## NOTICE OF DECISION

**TENTATIVE PARTITION PLAN / CLASS 2 ADJUSTMENT CASE NO.: PAR-ADJ24-11**

**APPLICATION NO.: 24-105587-PLN**

# PROPOSED LAND PARTITION (OPTION 2) 2886 BROOKS AVENUE NE

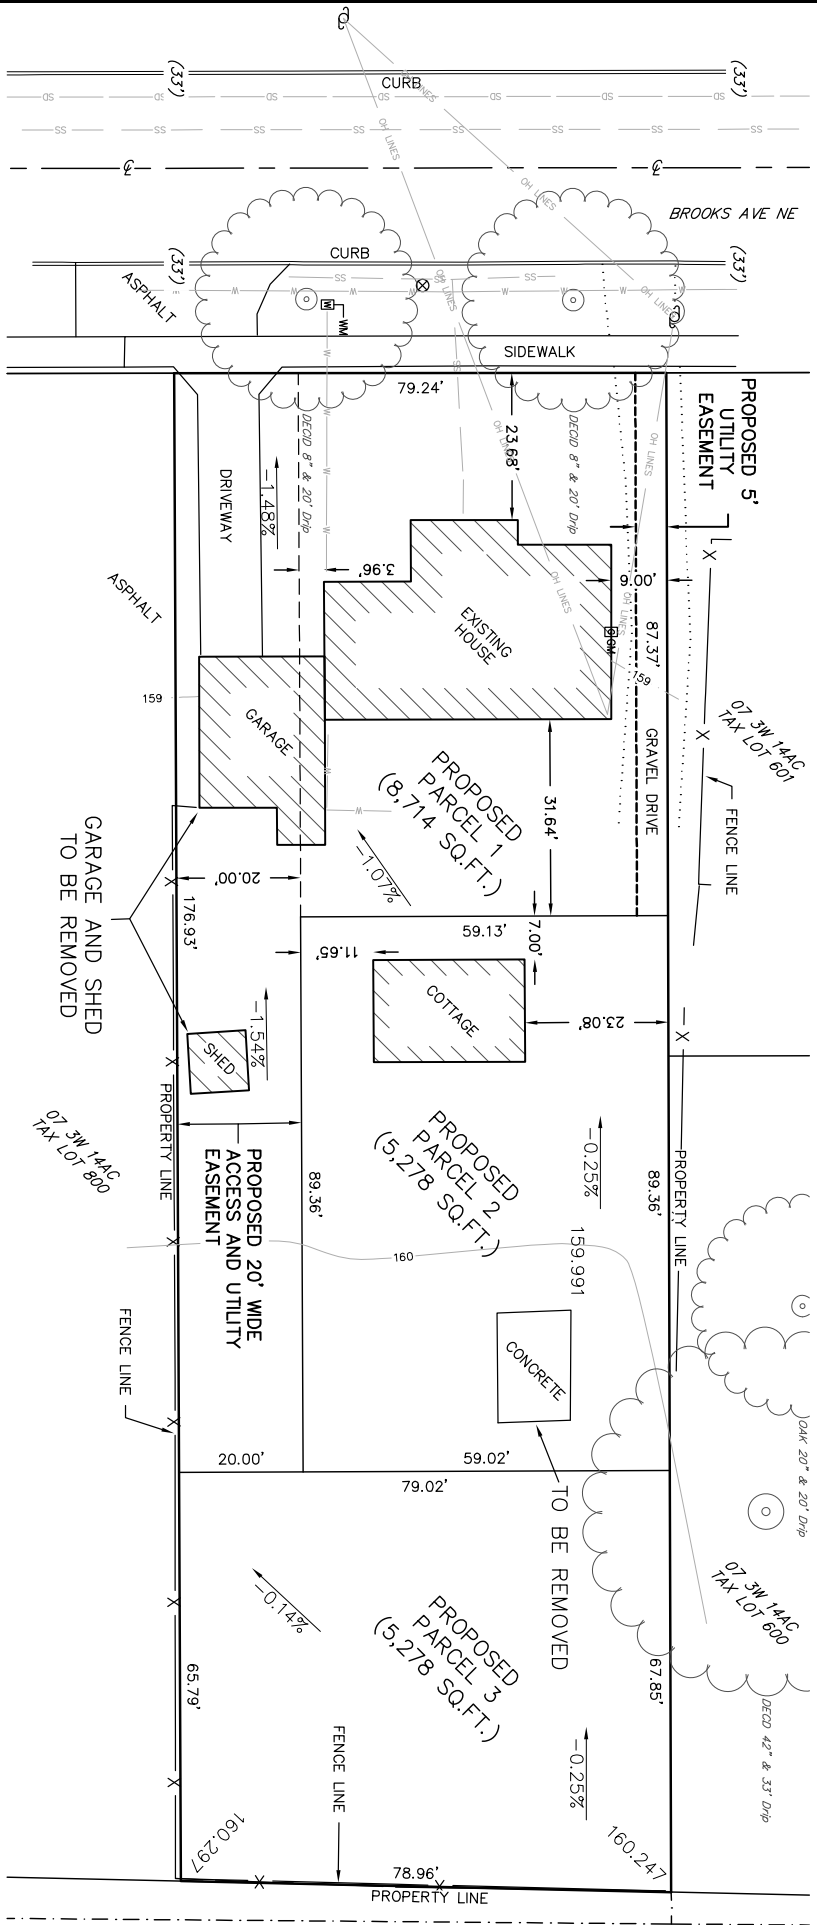
**Finding:** As shown on the tentative partition plan (**Attachment B**), proposed Parcel 1 is 5,168 square feet, exclusive of the accessway, and would have 59 feet of frontage on Brooks Ave NE. The proposed parcel is 59 feet in width, exclusive of the accessway, and 87 feet in depth. Parcel 1 meets the area, width, depth, and frontage lot standards. Proposed Parcel 2 will be an infill flag lot 5,278 square feet in size with 59 feet of width and 89 feet of depth and will have access to Brooks Ave NE via the flag lot accessway. Proposed Parcel 3 will be an infill flag lot 5,278 square feet in size with 59 feet of width and 89 feet of depth and will have access to Brooks Ave NE via the flag lot accessway. Proposed Parcels 2 and 3 do not meet the minimum 5,500 square foot area required of an infill flag lot. To ensure the parcels meet the minimum area, the following condition shall apply.

The plans also indicate there is an existing “cottage” on proposed Parcel 2, which is classified as an accessory structure. By definition, an accessory use cannot be permitted without a primary use on the property; therefore, in order to create the parcel, the accessory structure shall be removed or obtain the necessary permits to convert it to a standalone dwelling on the new parcel. To ensure the proposed partition plan meets the development standards of the RS zone, the following condition shall apply.

**Finding:** The tentative plan indicates the proposed flag lot accessway will be 177 feet in length by 20 feet in width, which, per Table 800-1, could serve a maximum of two dwelling units. With the existing dwelling on proposed Parcel 1, the flag lot accessway will serve three parcels and up to four units. The proposed accessway length is more than the maximum 150 feet length allowed and less than the minimum 25 feet in width to serve three to four units between the three parcels. Due to the location of the existing house and the infeasibility of providing a wider and longer accessway, the applicant has requested a Class 2 Adjustment to this standard, addressed in Section 9 below. To ensure the flag lot accessway can serve the three parcels and up to three-to-four units, the following condition shall apply.

**Finding:** Public water, sanitary sewer, and stormwater infrastructure is available along the perimeter of the site and appears to be adequate to serve the property as shown on the applicant's preliminary utility plan. As specified in the conditions of approval, private water, sewer, and storm services shall be constructed to serve each lot as a condition of plat approval. This shall include the requirement to provide individual services for the single-family dwelling that is planned to remain on proposed Parcel 2 (labeled as "cottage" on the plans). All public and private City infrastructure proposed to be located in the public right-of-way shall be constructed or secured prior to final plat approval except as authorized in an improvement agreement per SRC 205.035(c)(7)(B). In order to ensure the parcels are served by public utilities, the following conditions apply.

**Finding:** Any easements needed to serve the proposed parcels with City infrastructure shall be shown on the final plat. The applicant's tentative plan shows a proposed 20-foot-wide access and utility easement to serve Parcel 2 and 3.

**Finding:** The subject property is currently served by two 10-foot-wide driveway approaches onto Brooks Avenue NE, one along the northern property boundary and one along the southern property boundary. The driveway approach along the northern property boundary does not serve an approved off-street parking or vehicle storage area, pursuant to SRC 806.025. Pursuant to SRC 804.030(b)(1) driveway approaches onto local and collector streets shall only provide access to a permitted parking or vehicular use area. In addition, SRC 804.050(b)(1) Table 804-1 requires a minimum 10-foot-wide width for driveway approaches. As a condition of approval, the applicant shall close the driveway approach along the northern property boundary and replace with curbs, a landscape strip, and sidewalk.

The driveway approach along the southern property boundary will serve the proposed flag lot accessway for proposed Parcels 1, 2 and 3 of the partition. The existing approach is approximately 10 feet in width and not constructed to meet current *Public Works Design Standards*. Pursuant to SRC 800.025(c) Table 800-1, a flag lot accessway serving two units shall have a minimum 15-foot paved width; however, as a condition of approval, the applicant is required to pave the flag lot to 20-feet in order to provide access to the three proposed parcels. As a condition of approval, the applicant shall reconstruct and widen the southern driveway approach to meet current *Public Works Design Standards* and meet the minimum width required to serve the flag lot accessway.

The applicant's plan indicates the attached garage of the existing dwelling of Parcel 1 will be removed to accommodate the flag lot accessway. With the removal of the garage, the plans indicate the existing house will have a minimum setback of four feet from the proposed 20-foot-wide accessway. Due to the existing house and required setback, the accessway cannot be further widened without further alterations to the house. As proposed, the 20-foot accessway could only serve two units, limiting its access for proposed Parcels 2 and 3 only. Given the length of the existing lot at 242 feet, an accessway with a minimum 20-foot width and maximum 150-foot length would only allow for one exceptionally large lot in the rear of the property.

**Condition 1:** Prior to final plat, the applicant shall revise the proposed partition plan to ensure proposed Parcel 2 and Parcel 3 meet the minimum lot standards of SRC 511.010, Table 511-2.

**Condition 2:** Prior to final plat approval, obtain a demolition permit to remove the existing garage on the south side of the existing residence on Parcel 1, as well as the accessory structure within the proposed flag lot accessway. A minimum three-foot setback to the proposed flag lot accessway is required for any part of the existing dwelling on the parcel.

**Condition 3:** Prior to final plat approval, obtain a demolition permit to remove the existing accessory structure on proposed Parcel 2 or obtain the required building permits to establish it as a standalone dwelling.

- **Condition 4:** Prior to final plat, if the accessory building on Parcel 2 is to remain, the applicant shall revise the proposed plat to ensure the building meet the minimum setback standards of SRC 511.010, Table 511-3.

**Condition 14:** Prior to final plat or delayed pursuant to improvement agreement per SRC 205.035(c)(7)(B), the applicant shall permanently close the driveway approach along the northern property boundary and replace with curbs, a landscape strip, and sidewalks.

**Condition 16:** Prior to final plat, two trees shall be planted on Parcel 1 to meet the minimum amount required, per SRC 808.050, Table 808-1.
